# UNITED STATES PATENT AND TRADEMARK OFFICE

APPLICATION NO.	FILING DATE	FIRST NAMED INVENTOR	ATTORNEY DOCKET NO.	CONFIRMATION NO.
10/737,278	12/16/2003	Tilo Dittrich	DT-6693	6177
30377	7590	11/01/2005		
DAVID TOREN, ESQ. ABELMAN FRAYNE & SCHWAB 666 THIRD AVENUE NEW YORK, NY 10017-5621			EXAMINER CHUKWURAH, NATHANIEL C	
			ART UNIT 3721	PAPER NUMBER

<b>Office Action Summary</b>	<b>Application No.</b> 10/737,278	<b>Applicant(s)</b> DITTRICH ET AL.	
	<b>Examiner</b> Nathaniel C. Chukwurah	<b>Art Unit</b> 3721

### **DETAILED ACTION**

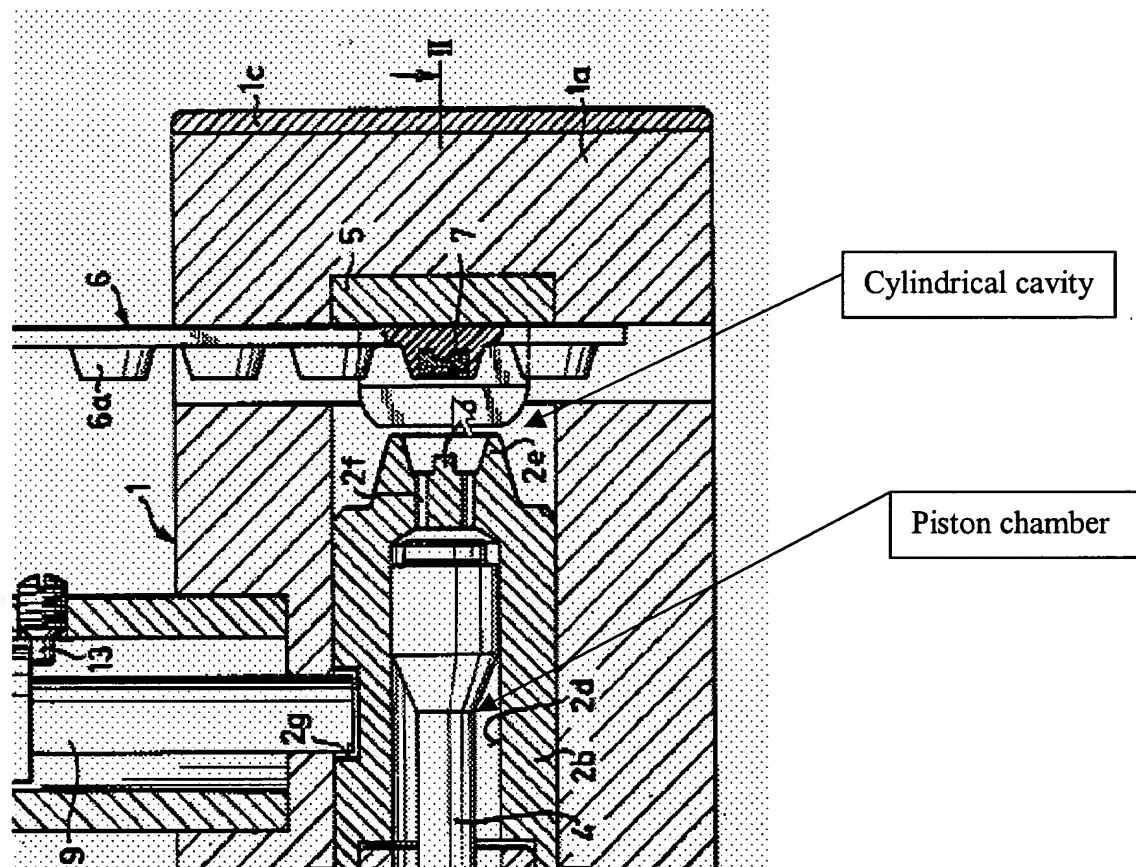
With regard to claim 1, Maier discloses an explosive-operated power tool comprising: a housing (1, 21, 41) having a cylindrical cavity (see arrow in Fig. below), and a piston chamber (see arrow in Fig. below), for receiving a drive piston (4), a breech bottom (5, 22, 42) located opposite the cavity and fixedly secured relative to the housing (1, 21, 41), a sealing sleeve (2b, 23b, 46) located in the cavity (see arrow in Fig. below) of the housing (1, 21, 41) and displaceable axially away from the breech bottom (5, 22, 42), and a cartridge (6a).

With regard to claim 2, the central axes of the cavity and the piston (4) extend at an angle to each other (see the Fig below).

With regard to claim 5, the sealing sleeve has surfaces (see arrow in Fig. below) which provide for displacement of the sealing sleeve (2b, 23b, 46) toward the breech bottom (5, 22, 42).

With regard to claim 6, the bottom surface of surface 2 as shown the Figure below is spaced from a bottom of the cavity when sealing sleeve receives the cartridge (6). See also Fig. 2 of Maier reference.

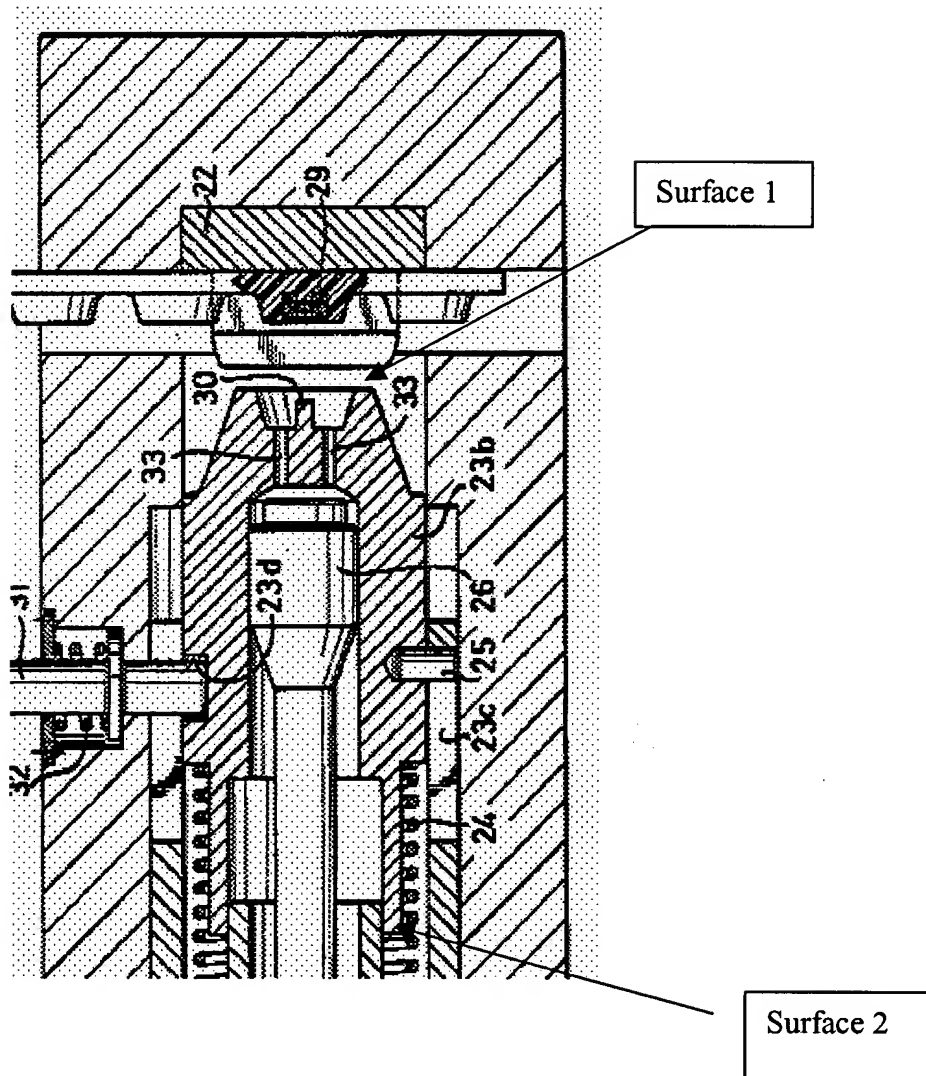
With regard to claim 14, Maier discloses an actuation element (2a, 23a) provided at a front end of the tool and displaceable relative to the housing (21, 41) for operating a mechanism (23a, 24) for displacing the sealing sleeve (23b, 46), the displacing mechanism displacing the sealing sleeve (23b, 46) toward and away from the breech bottom (22, 42) upon displacement of

the actuation element (2a, 23a) toward the housing (21, 41) and away from the housing , respectively.

With regard to claim 15, the displacing mechanism (23a, 24) comprising actuating pipe (10) including latch (9) and spring (12) for retaining the sealing sleeve (2b, 23b) wherein actuating pipe (10) including latch (9) lift against the spring force displacement of the actuation member (2a, 23a) toward the housing, and which is equivalent to the spring fork as claimed.
